Groundwater & Wastewater Services
Septic Project File & Data Review Worksheet

GWS File #: 7030 B WASPS App #: 2060

IMPROVEMENT PERMIT for a RESIDENTIAL ON-SITE WASTEWATER TREATMENT & DISPOSAL SYSTEM

Reference: **Request for a Septic Improvement Permit for Lot 127 at The Sanctuary at Lake Wylie Phase 4b**
Mecklenburg County Health Department (MCHD) File # 7030B

Design Specifications for Lot 127 at The Sanctuary
MCHD File # 7030B

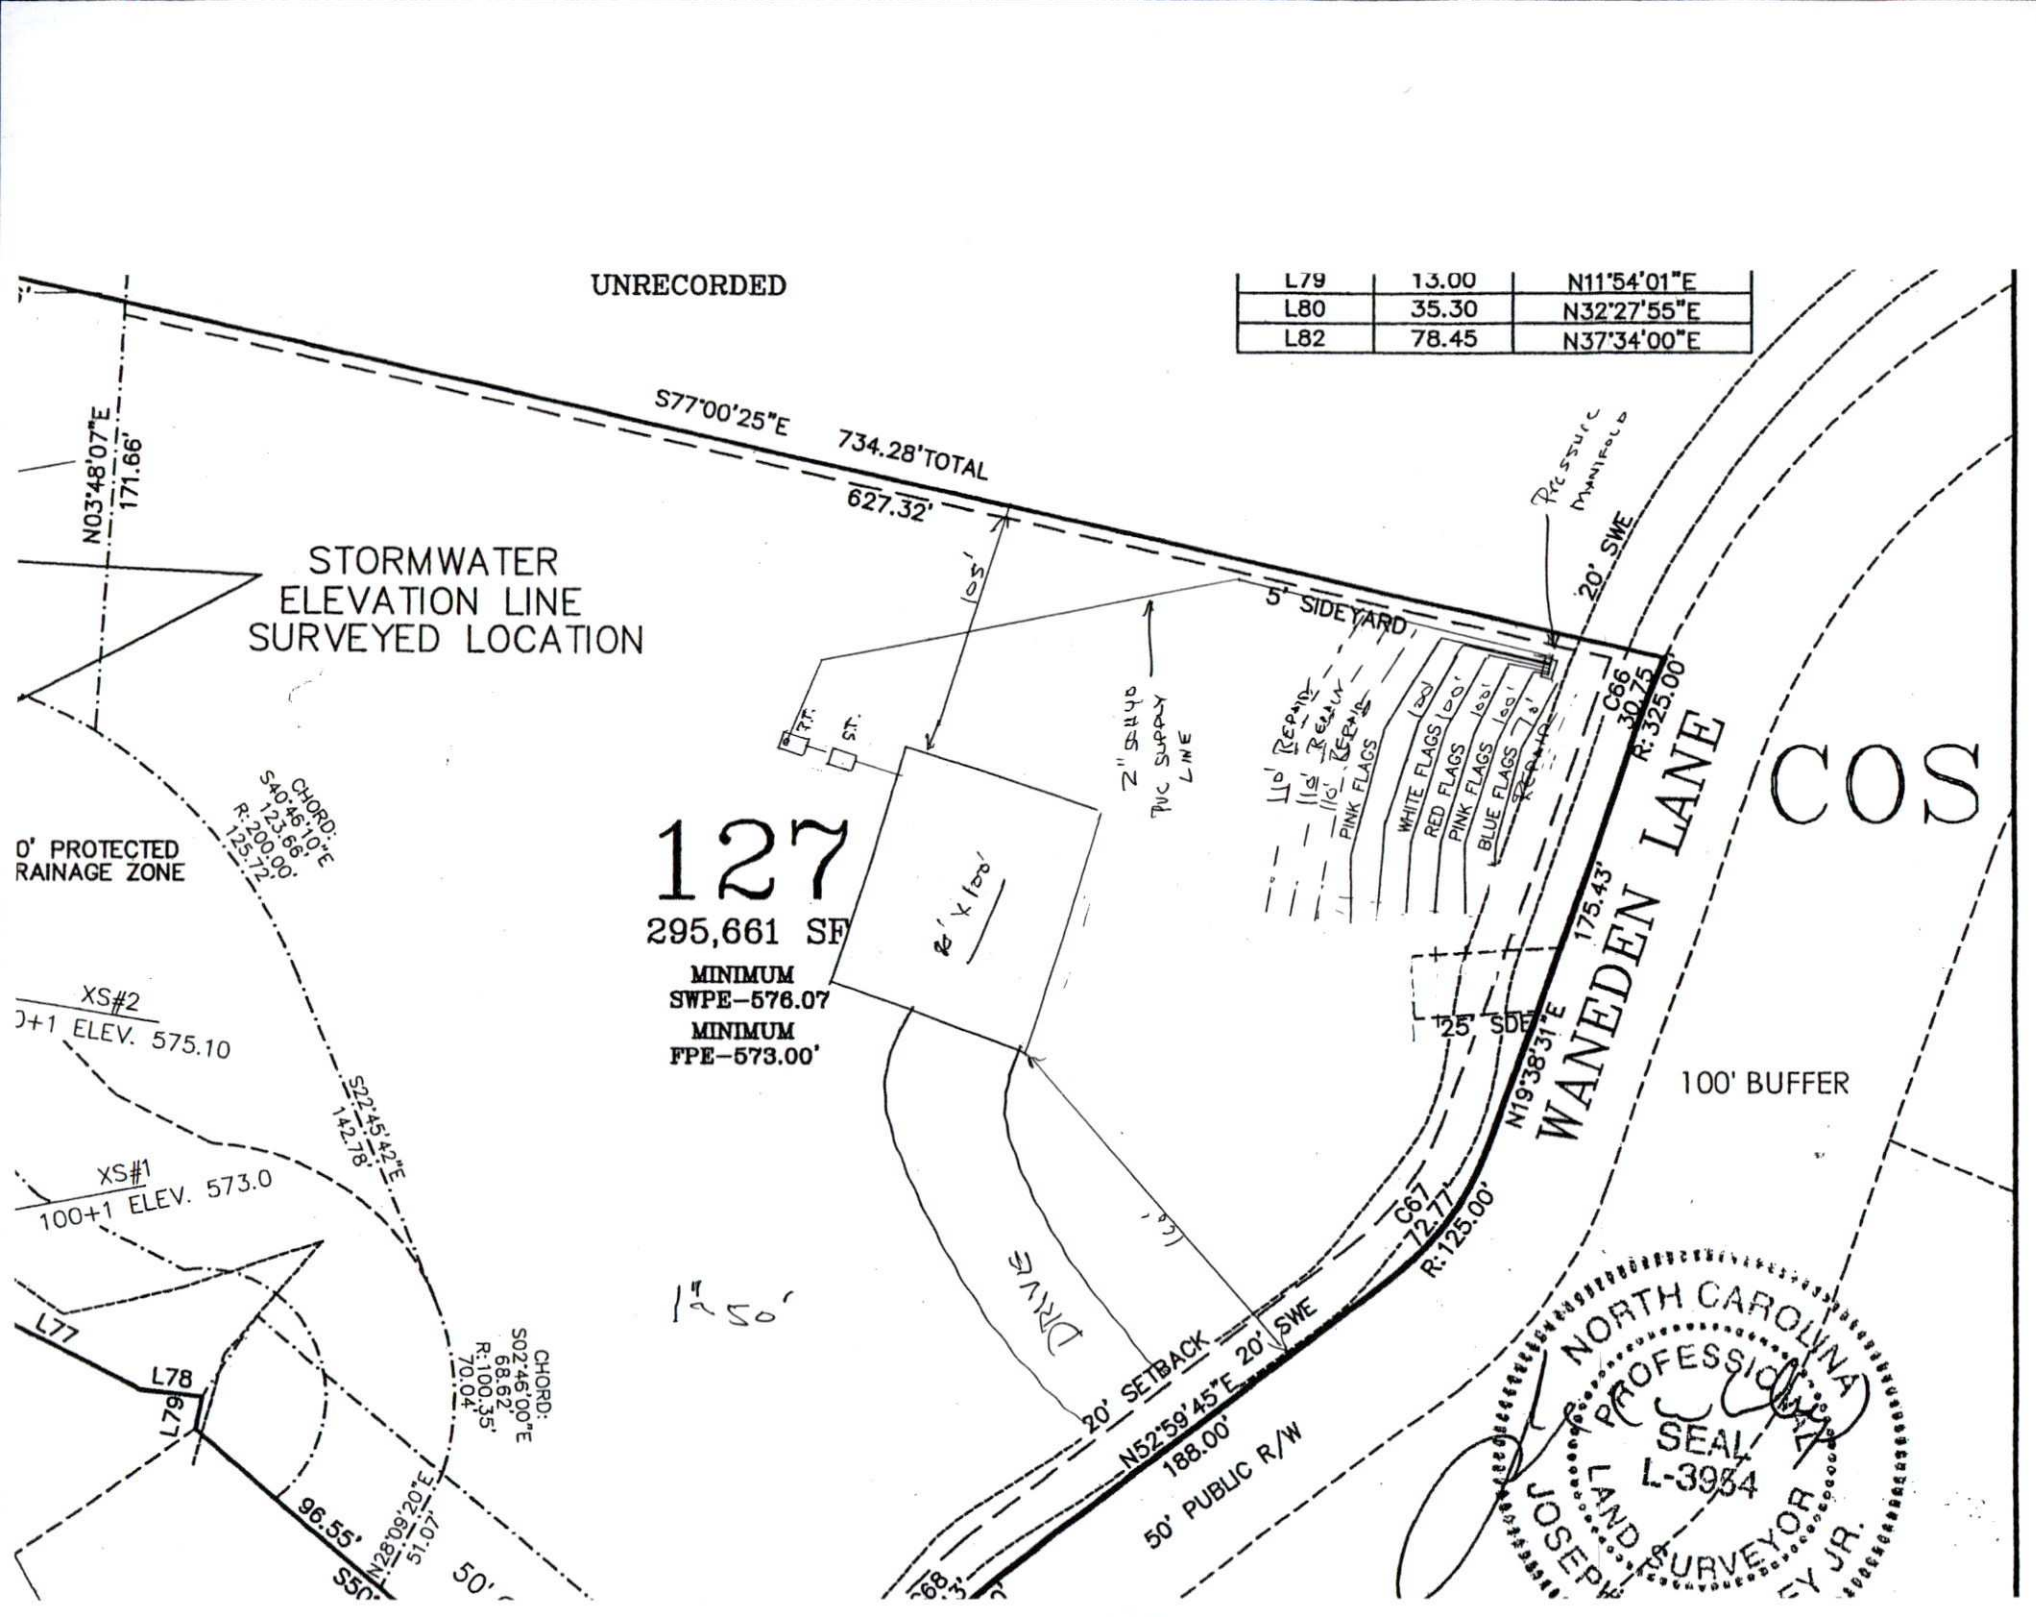
Paul said to load at .3. He has 500' line for 5BR house. Call Paul at (704)996-6330 if you have questions.

.1937(m)	Are the Profile Locations Shown?	4 ☑		
.1939(a)	Are the S/PS Profiles in system & in repair area?	Yes ☐	No ☐	N/A ☐
& .1945(b)	Number of auger borings made: 3 Were sufficient auger borings made?	Yes ☑	No ☐	N/A ☐
.1939(d), .1955, .1956, .1957	LTAR .3 DIFFERENT LTAR .32F ON PLAN	Yes ☐	No ☐	N/A ☐
	Improvement Permit/Construction Authorization			
.1937(g) 130A-336(a)	Proposed System Type stated-Initial	Yes ☑	No ☐	N/A ☐
.1945(b)	Proposed System Type stated-Repair	Yes ☑	No ☐	N/A ☐
130A-336 (a)(3)	System location identifiable by setbacks - Initial	Yes ☑	No ☐	N/A ☐
.1937(g) .1945(b)	System components shown – Initial	Yes ☑	No ☐	N/A ☐
.1945(b)	Repair area shown	Yes ☑	No ☐	N/A ☐
.1937 (f)(g)	Does System design match facility, flow & WWcharacteristics?	Yes ☑	No ☐	N/A ☐
.1937 (f)(g)	Is System design consistent with soil/site conditions?	Yes ☑	No ☑	N/A ☐
.1937 (f)(g)	Is the System located in the approved area?	Yes ☑	No ☐	N/A ☐

Daily Design Flow:	600 gpd
Number Bedrooms:	5 bedroom
Basement or Crawl Space:	Basement
Septic Tank Size:	1500 gal
Pump Tank Size:	1500 gal
Primary System Loading Rate:	.3 ~~**0.325 gpd/ft^2**~~
Primary System:	**25% reduction**
Number and length of laterals:	5 @ 100 ft. endfed
Total ft. of primary system:	500 ft.
Flow Rate through system:	27.5 gpm – use ½ in. SCH 80 taps with 2 ft. head pressure on pressure manifold (5.5 gpm per tap)
Pump Requirements:	to be calculated by installer when specific house and pump tank locations are available
Dosing Volume:	approx. 270 gal. – 2.2 doses/day at design flow
Depth of effluent pumped per dose:	calculated to specific tank by measure or dealer engineering specifications (1 cubic ft. of water equals 7.48 gal.)
Check Valve:	yes
Siphon break hole:	no
Repair System Loading Rate:	.3 ~~**0.325 gpd/ft^2**~~
Repair System:	**LPPPBPS**
Total ft. of repair	400 ft. (308 ft. required)
